Statement of Environmental Effects

S.96(1A) Application to modify Project Approval 06/0191

Orica Southlands Remediation and Warehouse Project

Port Botany Industrial Estate, McPherson Street, Botany

Figure 3 - Proposed Site Plan

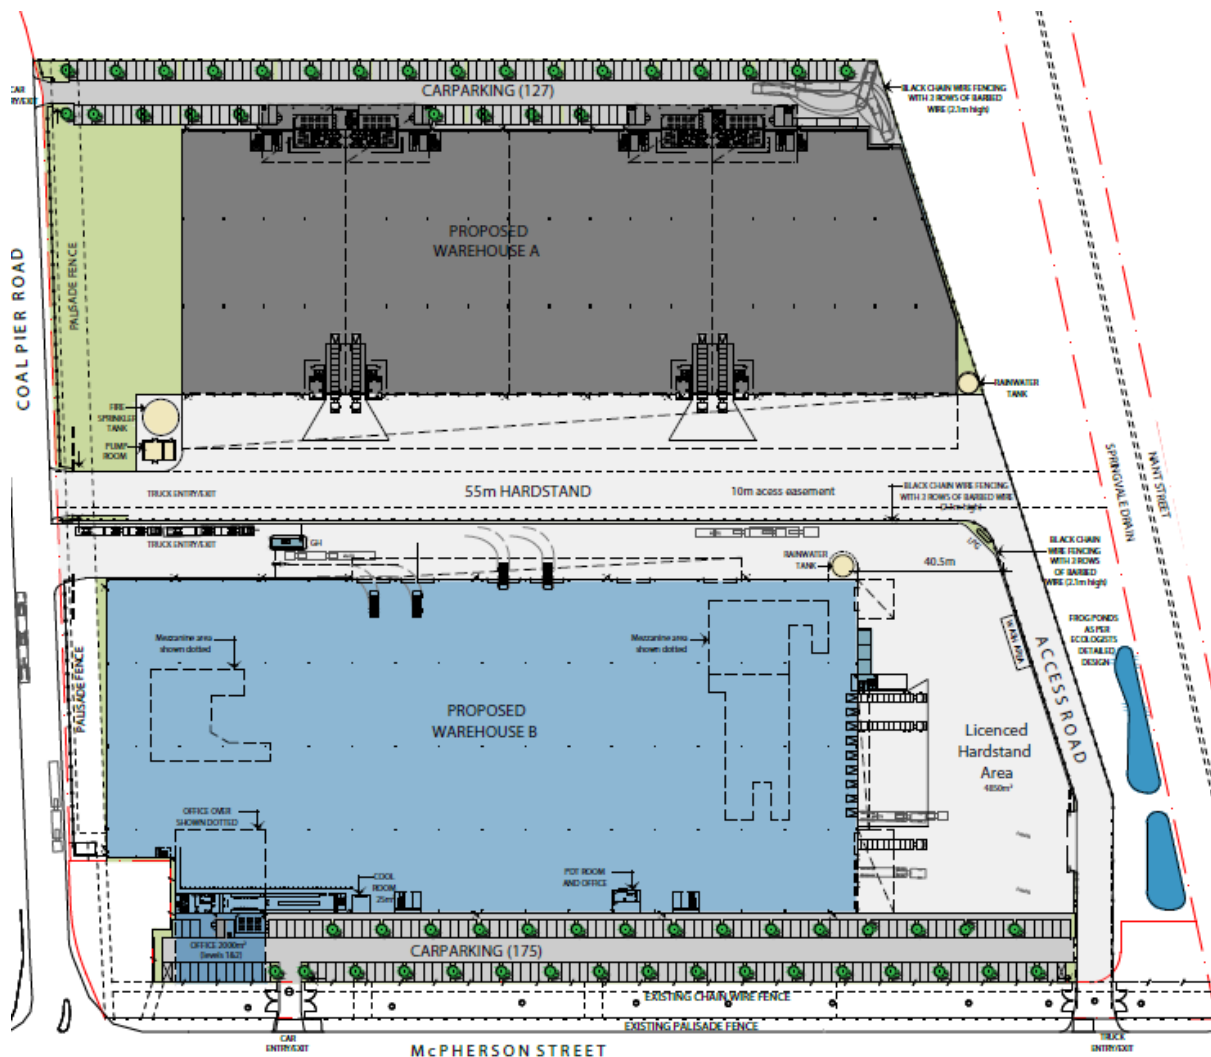
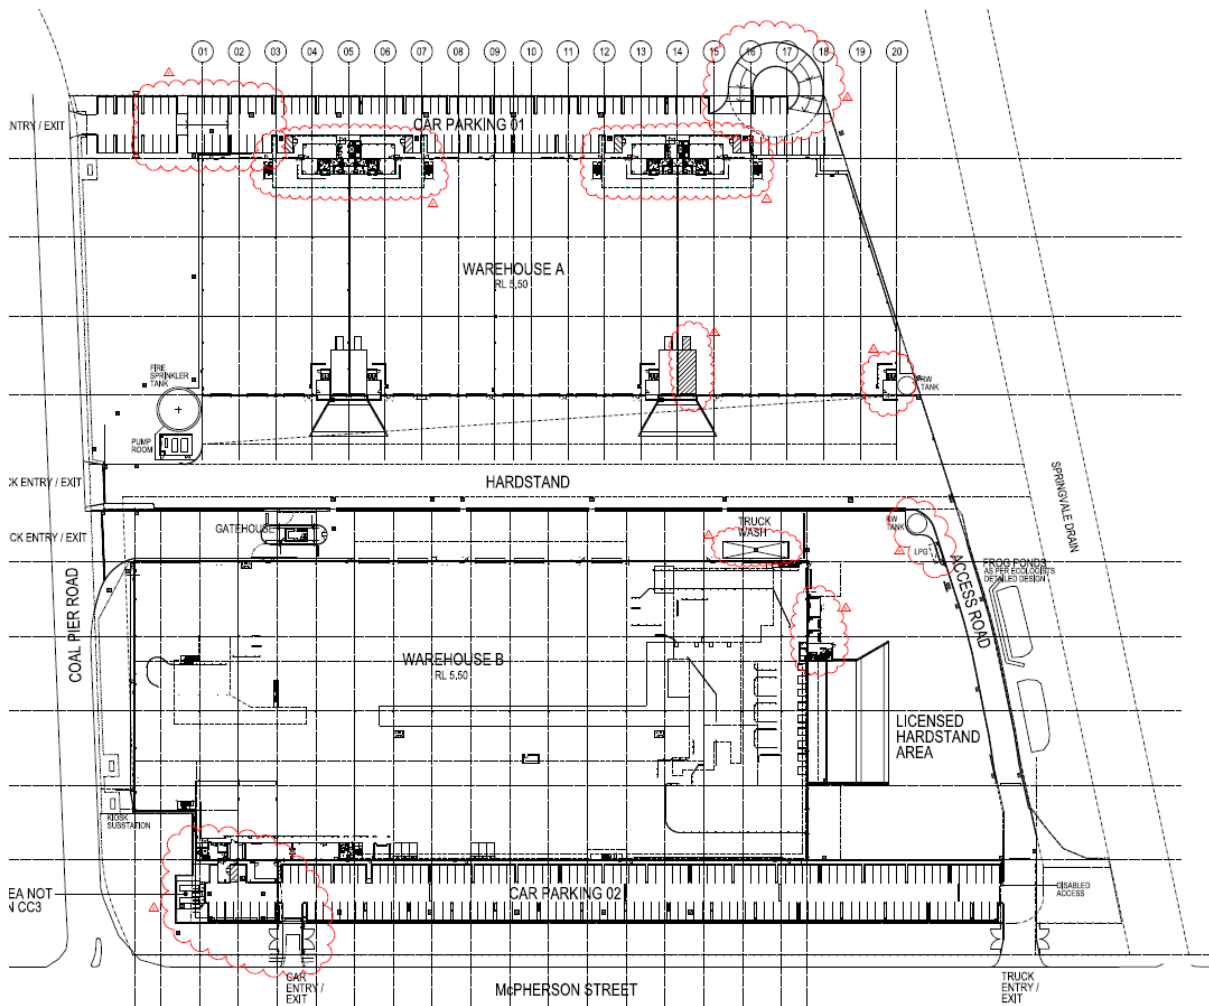
The proposed S.96 modifications are minor and are shown clouded in red in the following plan:

Figure 5 - Proposed Car Parking Layout and Turning Head for Warehouse A

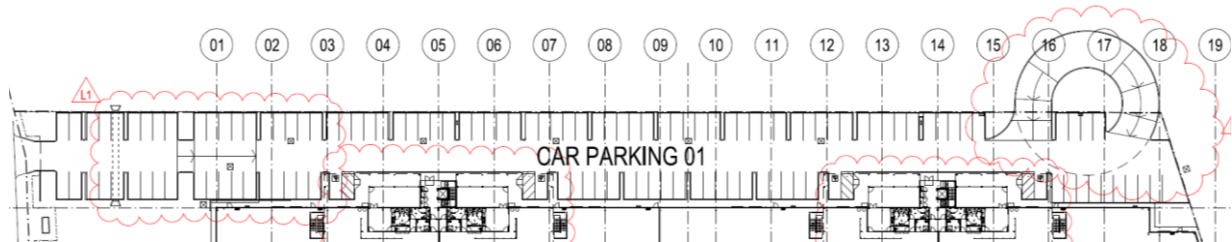
- + The NSW Fire Brigade have confirmed a turning head is required in the North Eastern portion of Warehouse A's car park. This is required to enable fire trucks the ability to turnaround to exit the site in a forward direction (refer to Figure 4 & 5 below).
- + Civil Engineers, Costin Roe, have confirmed that the design of the turning head in the supplementary civil plans (**Appendix B**) which is cantilevered over the flood basin will not have any impact on approved flood storage for the site (refer to **Appendix C**, and Section 4.3 below).

- + The car parking layout has been modified to make allowance for the proposed turning head, the provision of which will necessitate a reduction of two car spaces, from 127 to 125 spaces.

- + Despite this reduction in car spaces, Warehouse A continues to provide sufficient car spaces as required by tenants and in satisfaction of that required in accordance with City of Botany Council DCP 2013 (which requires a minimum of 91 car spaces (refer to **Section 4.4** below).

Figure 6 - Proposed additional drainage outlet

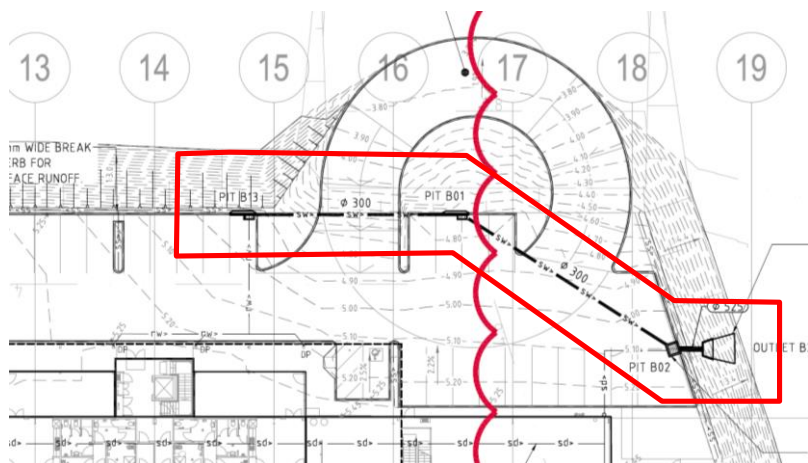
- + An adjustment to the approved drainage layout along the north eastern side of Warehouse A is proposed (refer to Figure 6 below). This includes the addition of a drainage outlet running in an easterly direction in the area of the turning head (refer to **Appendix B** for plans).
- + This proposed adjustment is necessary to limit works within the constructed Springvale Drain and associated floodway, reduce any impact of the turning head, and the extent of works required within contaminated land.
- + The adjusted design remains consistent with the approved stormwater management strategy defined in the approved documents (refer to **Appendix C** – Costin Roe letter, dated August 2015).

Figure 7 - Approved Warehouse A Office Mezzanine - Proposed for Removal

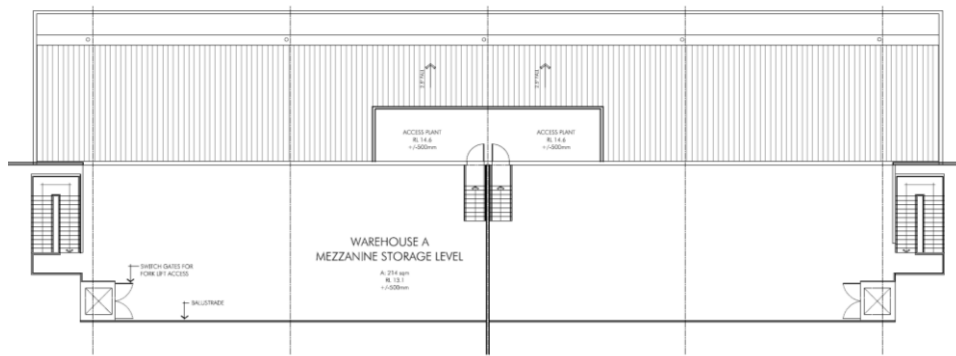
- + The mezzanine storage areas above the first floor office (drawing 4244_DA-16 in the approved set), is proposed for removal, resulting in an aggregate reduction of 964 m² of gross floor area.
- + This storage area is proposed for removal as it is not required by the tenant.

Figure 9 - Proposed new location for dock office in the south eastern corner of Warehouse A

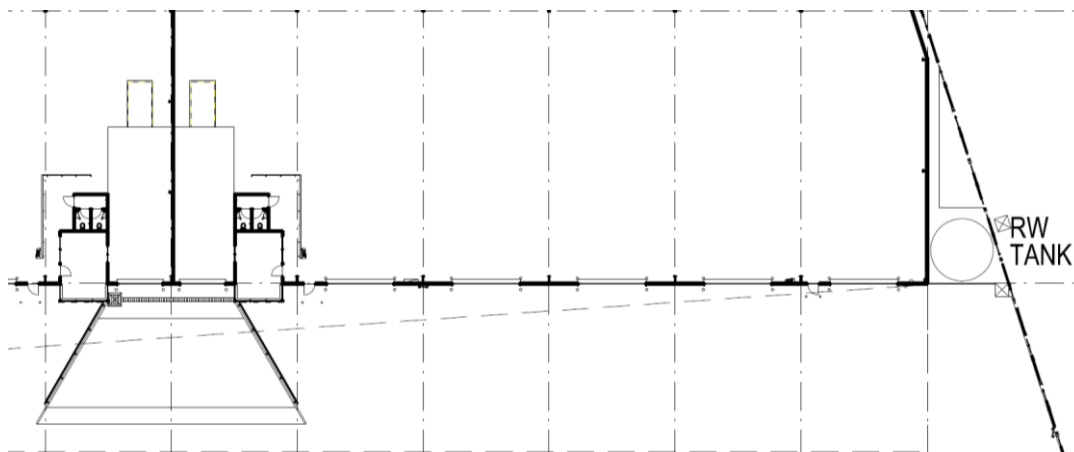
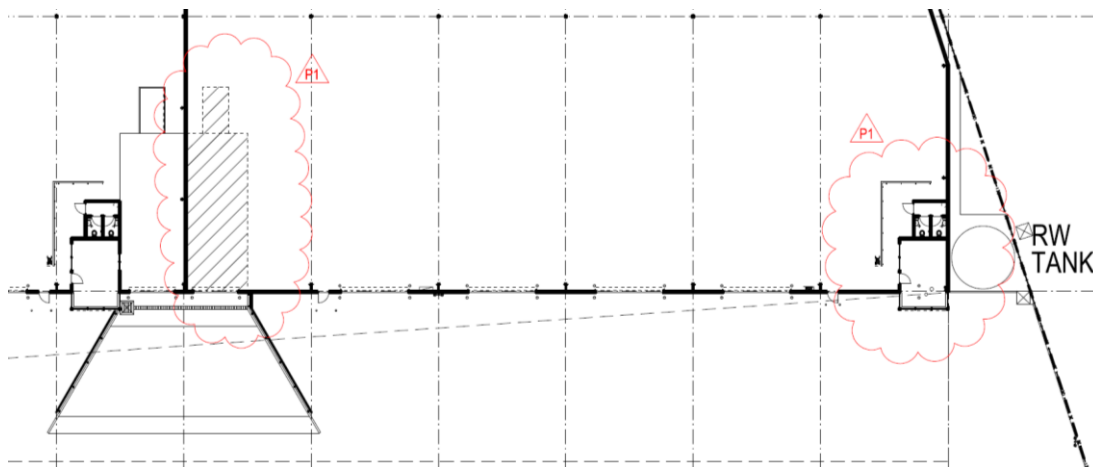
- + Movement of a dock office from the recessed dock to the south eastern corner of the warehouse building.
- + This will provide enhanced layout and enhanced access for staff at the corner of the building.

Figure 10 - Approved Warehouse B Dock Office layout

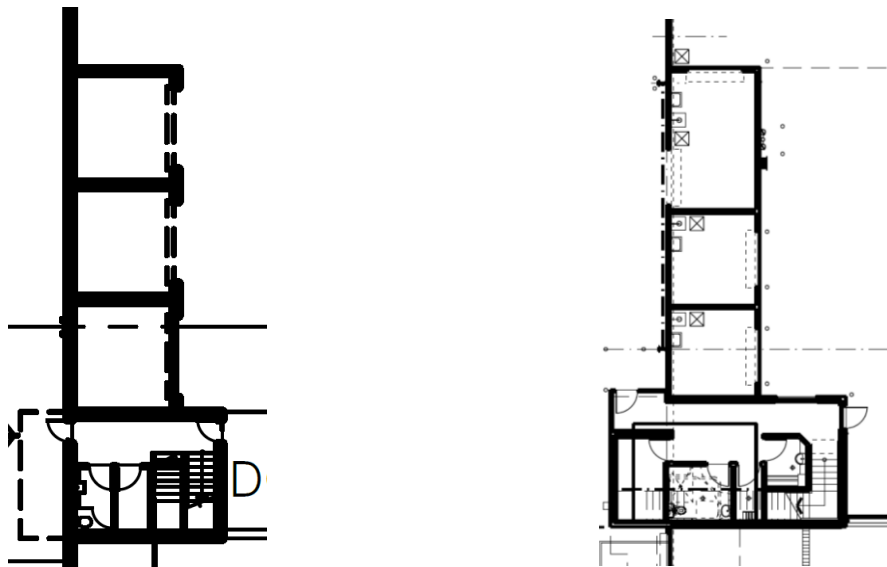
- + The layout and area of Warehouse B's control tower, located in the northeast corner of Warehouse B, is proposed to be modified slightly.
- + The floor area of the control tower is to be increased by has been increased by 40m² from 58m² to 98 m². (Refer to **Appendix A**, drawings GA-302, 306 & 319).
- + The proposed modification to size and layout of the dock office will enhance the use to better suit the tenant's needs.

Figure 11 - Approved Truck Wash and Rainwater Tank Location

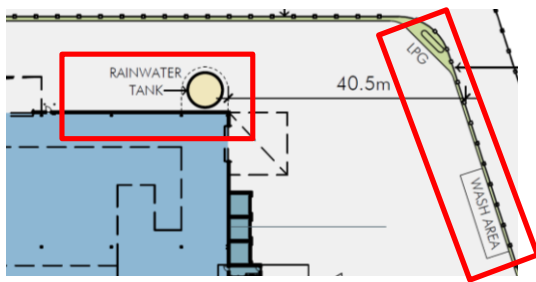
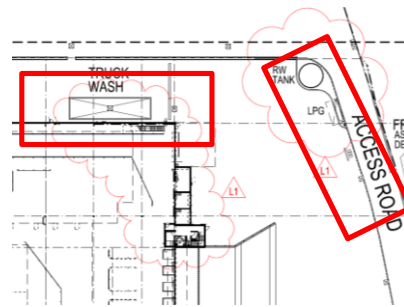
- + Warehouse B's rainwater tank is proposed to be relocated from the North Eastern corner of the building to the North Eastern corner of the site (refer to Figure 9 below). This proposed relocation will provide for enhanced layout and better vehicular flow around the warehouse.
- + The LPG gas storage area is proposed to be moved slightly north to make allowance for the rainwater tank relocation. A 6m X 3m awning is proposed to the LPG gas storage area. (Refer to **Appendix A** - drawings GA-101, 102, 113 & 380.) This awning will provide weather protection for the gas storage area and will have no impact to the surrounds.

- + The approved truck wash location is proposed to be relocated from the North Eastern corner of the site to along the North Eastern corner of Warehouse B.
- + The proposed relocation of the truck wash will allow for enhanced truck access and drainage arrangements for this wash area.
